December 19, 2022

ADDENDUM NUMBER ONE (1)

Project: Tippah County Hospital  
EMS Building  
PN: 22005

FROM: Dean Architecture, P.A.  
661 Sunnybrook Road, Suite 140  
Ridgeland, MS 39157  
(601) 939-7717

**1 FLOOR PLAN - POWER & SYSTEMS**  
E201 SCALE: 1/4"=1'-0"

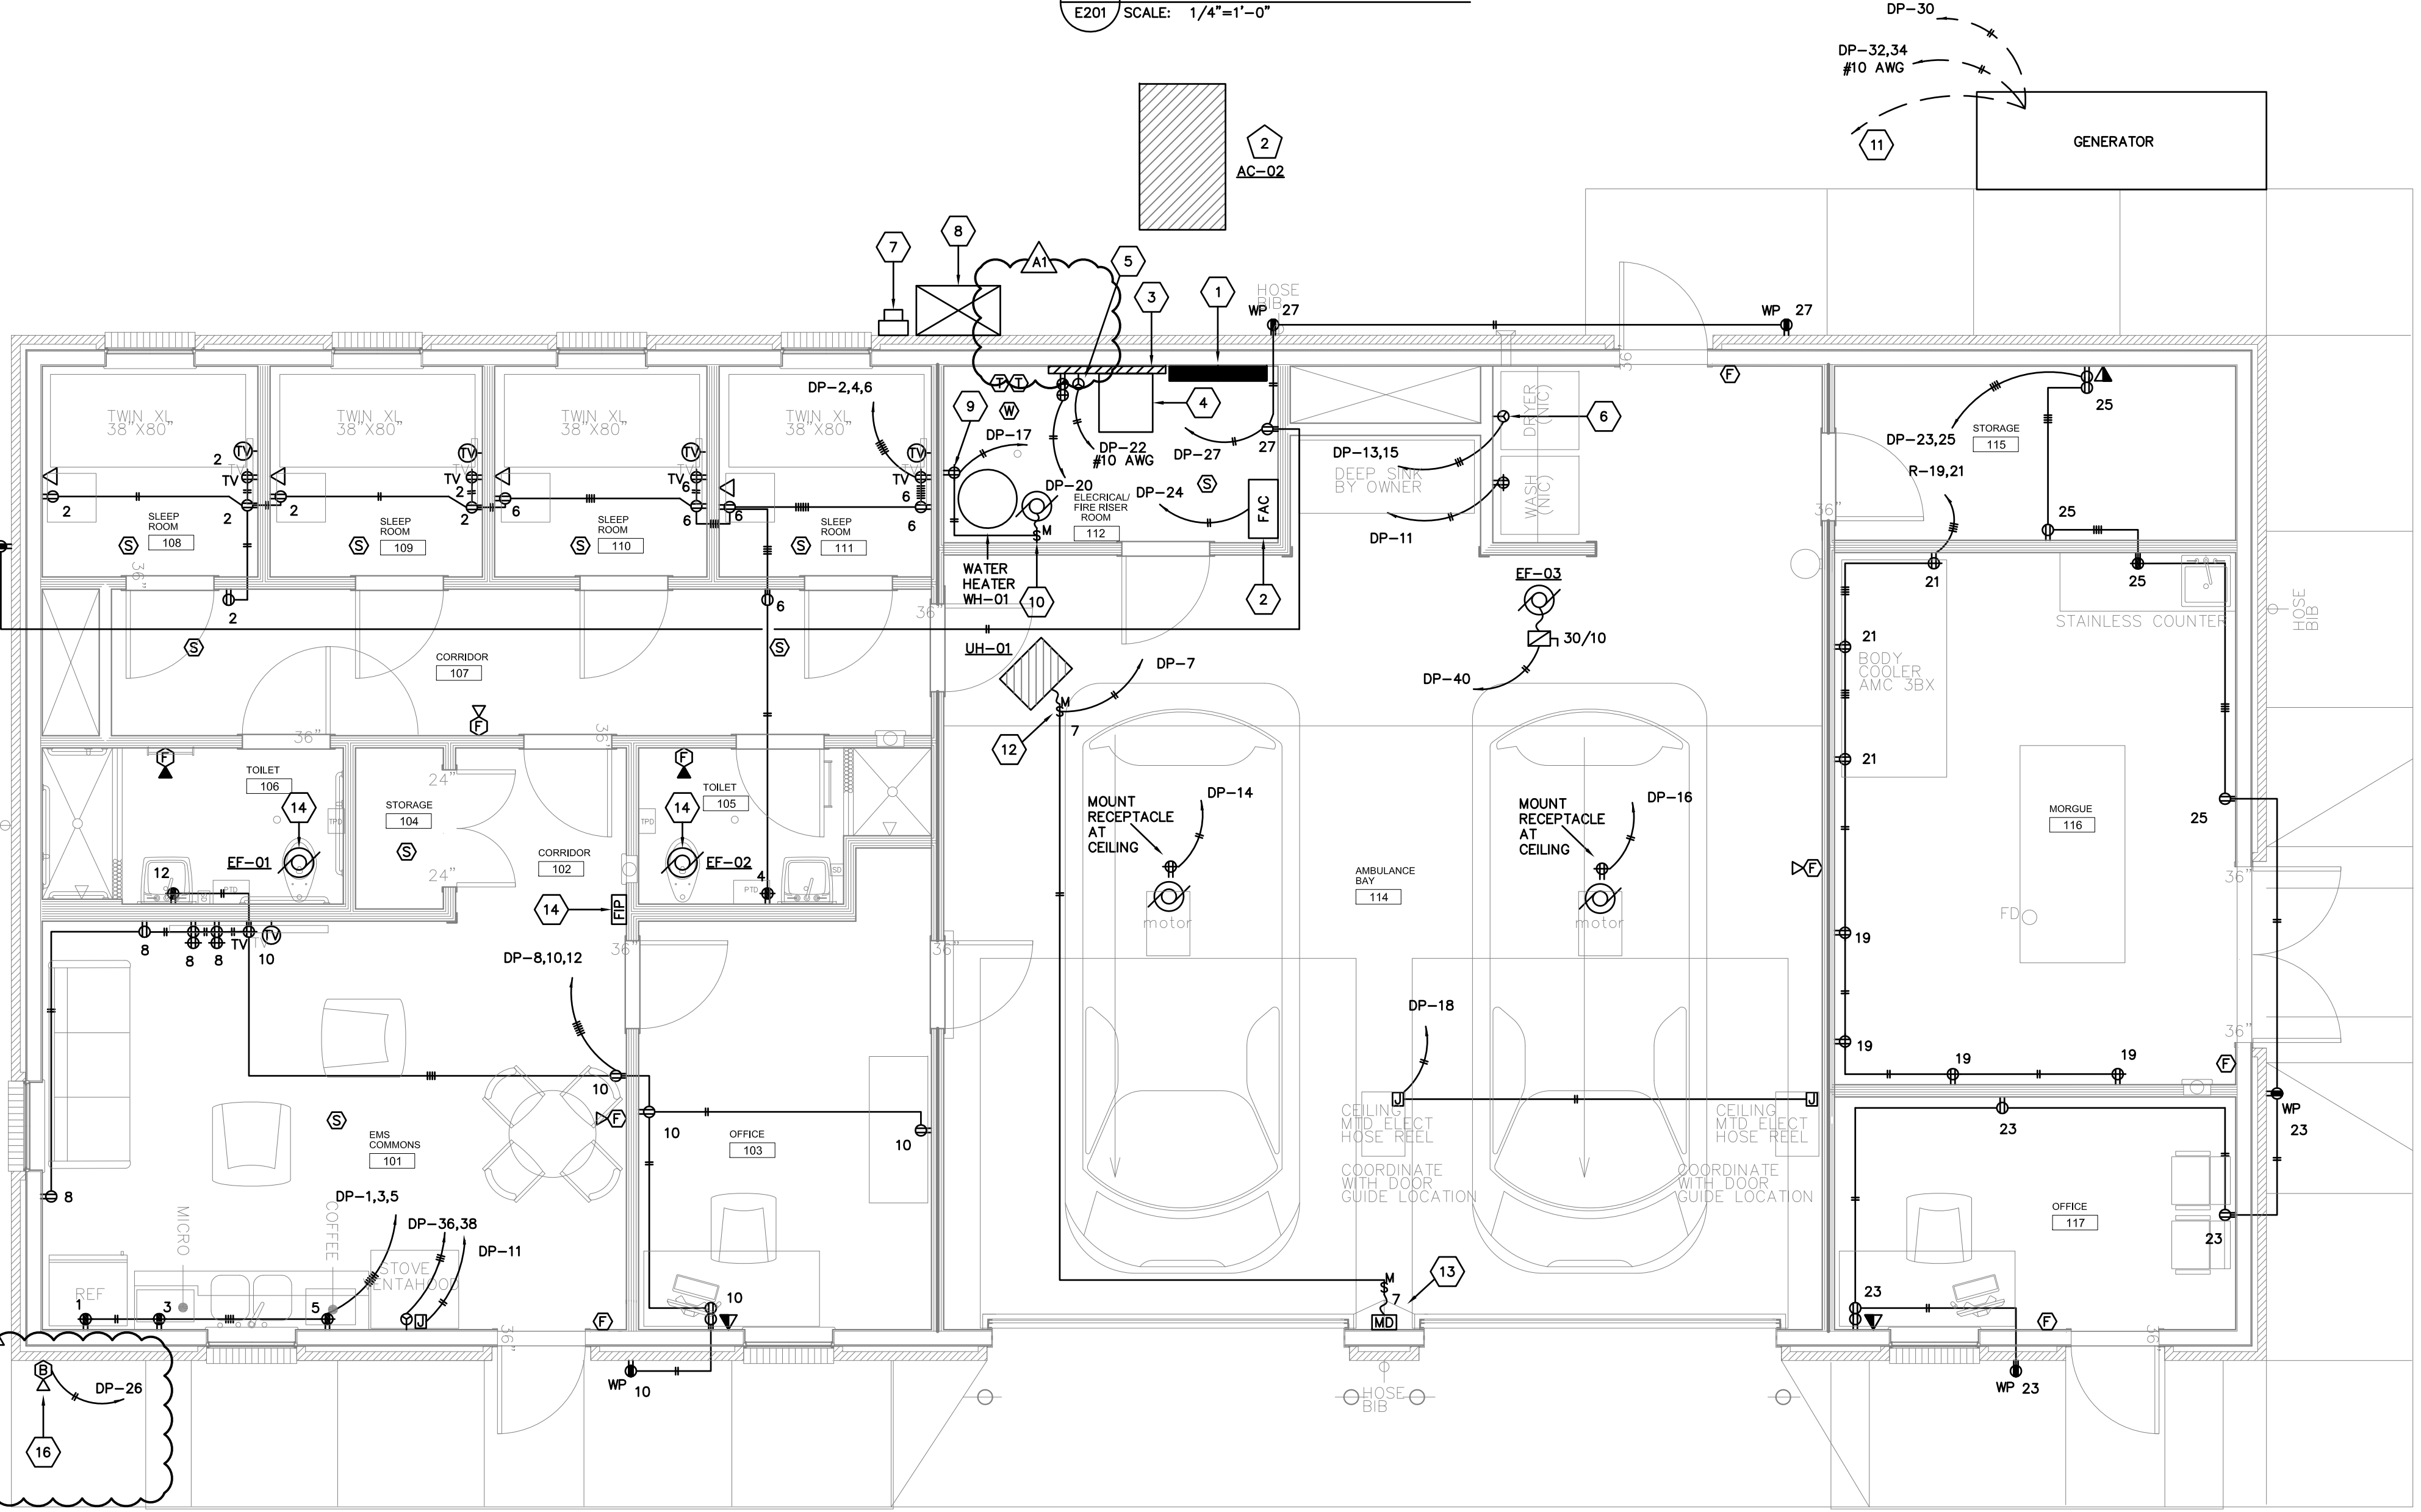
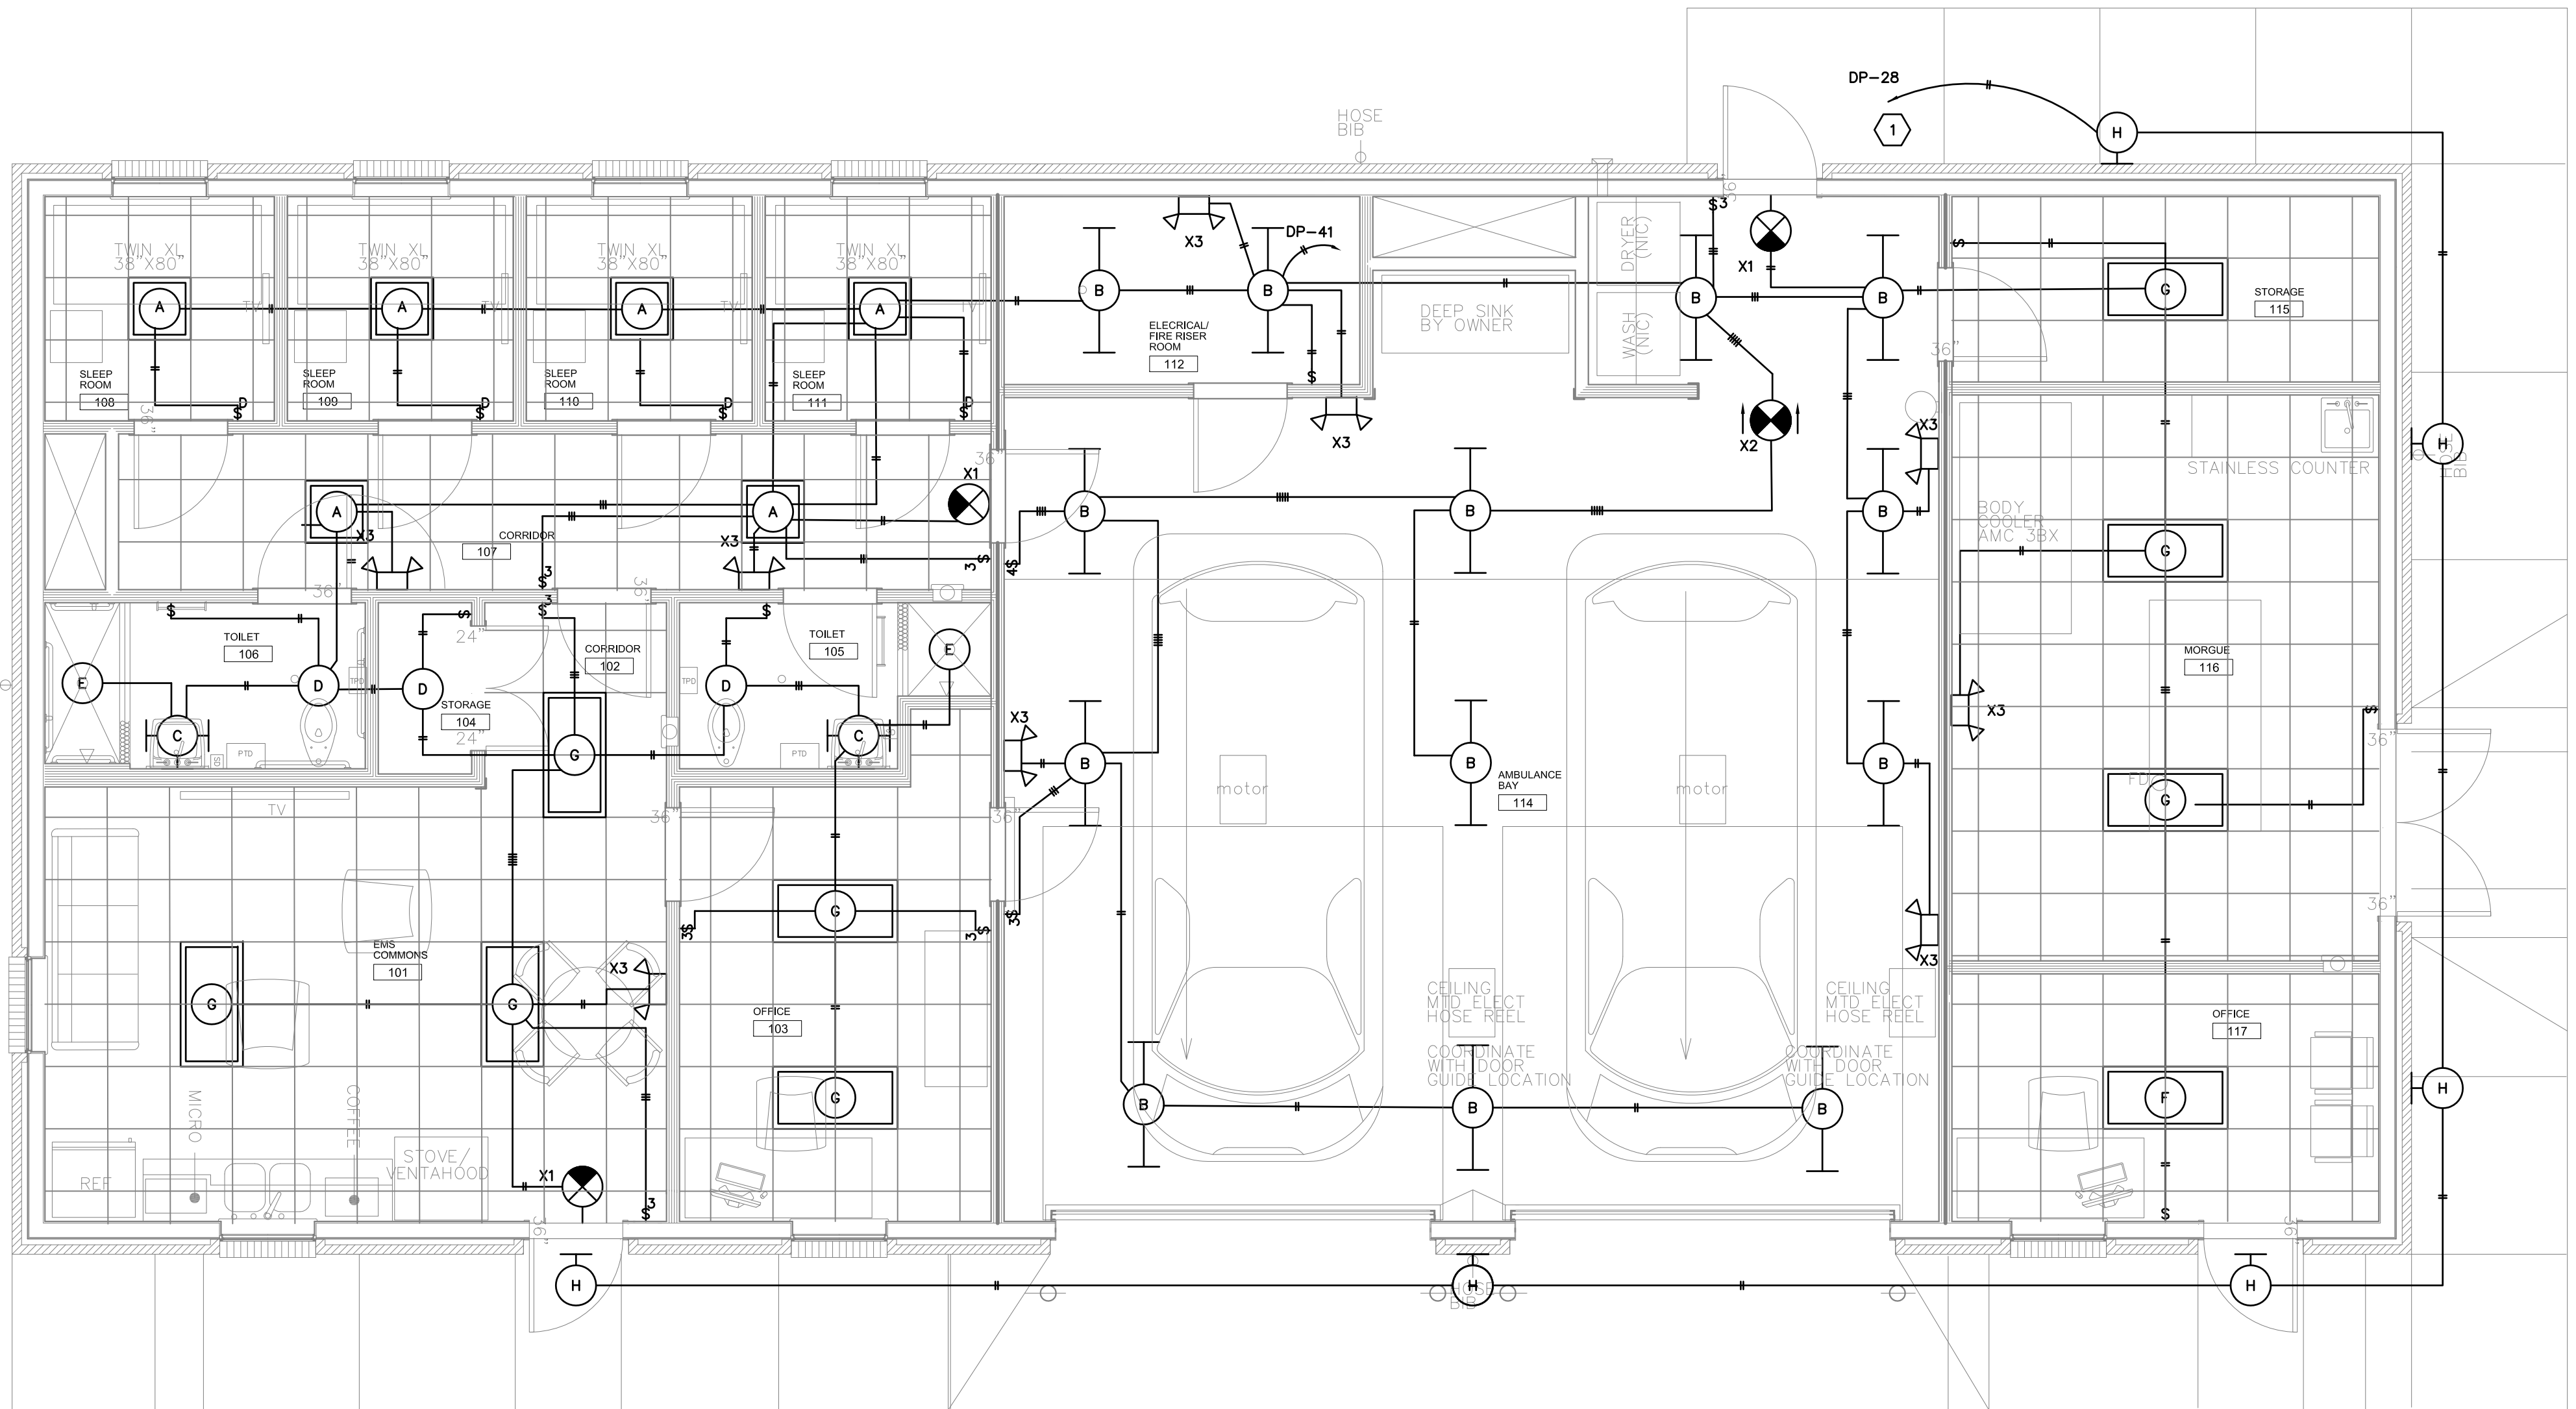
1. The Fire Suppression System Riser Bell has been relocated to the southeast corner of the building.

- 16 FIRE SUPPRESSION SYSTEM RISER BELL. PROVIDE 120V CONNECTION TO BELL. FIELD VERIFY EXACT LOCATION AND MOUNTING HEIGHT WITH MECHANICAL CONTRACTOR PRIOR TO ROUGH-IN.
